DEPARTMENT OF BIODIVERSITY, CONSERVATION AND ATTRACTIONS REPORT

PROPOSAL	Redevelopment of Pier 21 Marina - removal of seven jetties and replacement with six new floating jetties with wave attenuation, public boardwalk and community use jetty
LOCATION	River reserve - Lot 300 on Plan 47450 (Reserve 48325) and Regional Open Space – Lot 505 and 506 on Plan 54517 (Reserve 49288) and Lot 431 on Plan 215710 (Reserve 43707)
COST	\$10,000,000
APPLICANT	Pier 21 Marina Pty Ltd
LANDOWNER	Swan River Trust and City of Fremantle
LOCAL GOVERNMENT	City of Fremantle
MRS CLASSIFICATION	Waterways; Regional Open Space
DECISION TYPE	Part 5, <i>Swan and Canning Rivers Management Act 2006</i> , Ministerial Determination
ATTACHMENTS	<ol style="list-style-type: none"> 1. Location Map (one page) 2. Amended Development Proposal: <ol style="list-style-type: none"> a) Amended plans and application (eighteen pages) b) Wake Wave Reflection Report (thirteen pages) c) Visual Impact Assessment (forty-six pages) d) Parking Assessment (nine pages) 3. Initial Development Proposal (nineteen pages) 4. External referral responses: <ol style="list-style-type: none"> a) City of Fremantle (eleven pages) b) Department of Wat

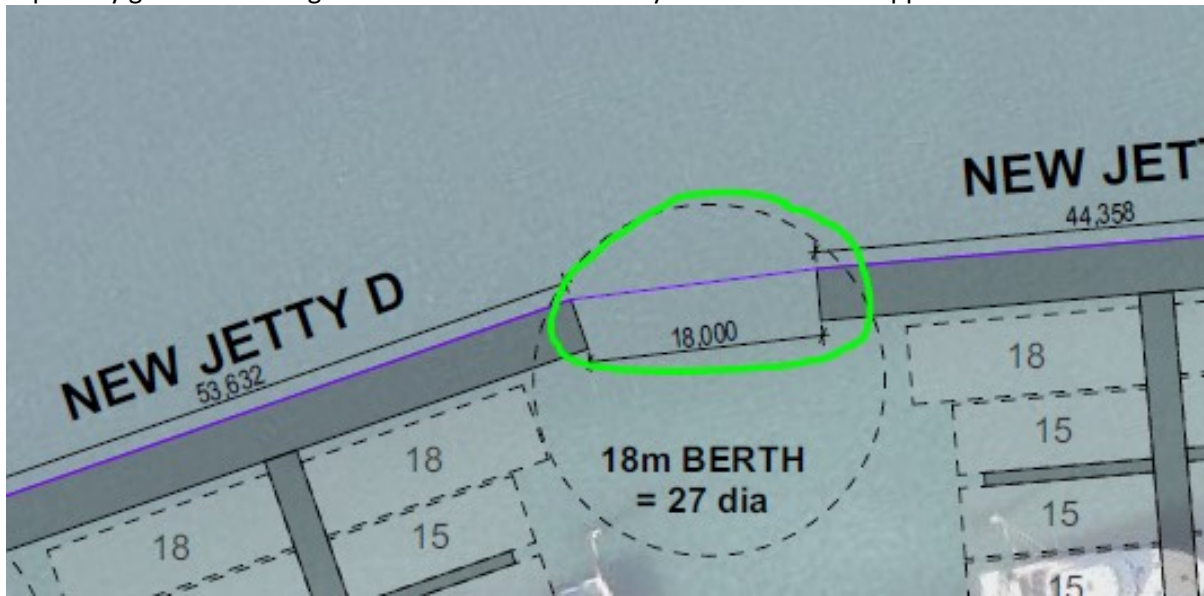
Mooring Piles: Mooring piles are not shown between berths. These should be considered, particularly for the larger pens.

Fairways / Internal Channels: The fairways and internal channels appear to meet the minimum requirements of AS3962 (1.5L). However, the pinch point at the T-Head of each fairway / channel does not meet this minimum requirement. This pinch point, being only 18m wide, could pose a safety concern for vessels entering and exiting the pen system, especially given the strong currents in the area. This layout would not be approved.

Berth Widths: While not all berth widths could be confirmed, they generally appear to comply with AS3962.

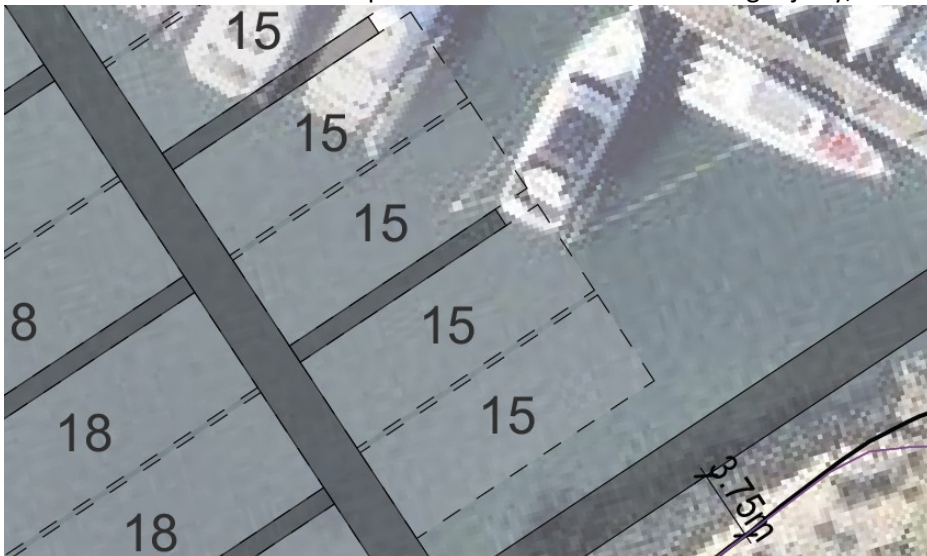
Inner Pens: Some of the inner pens do not have access to a finger jetty, as illustrated below.

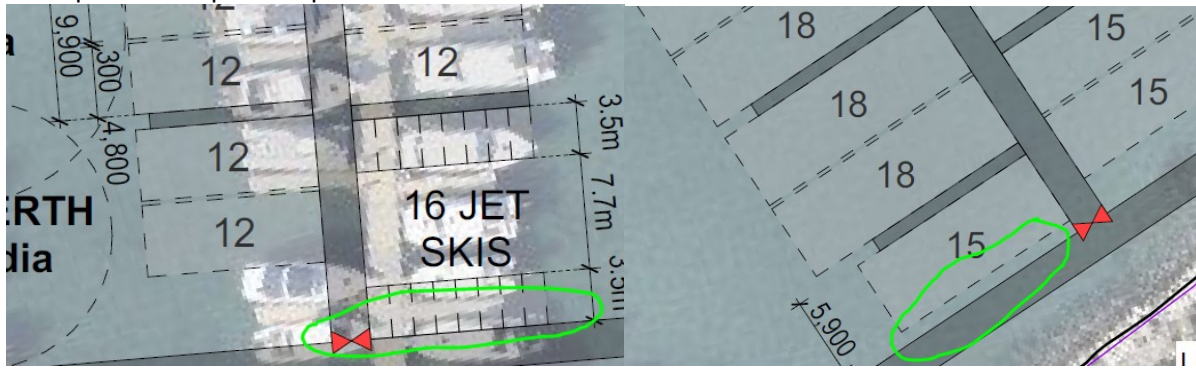
Security: There are potential security concerns with people on the public boardwalk being able to access some of the inner pens. Examples are provided below.
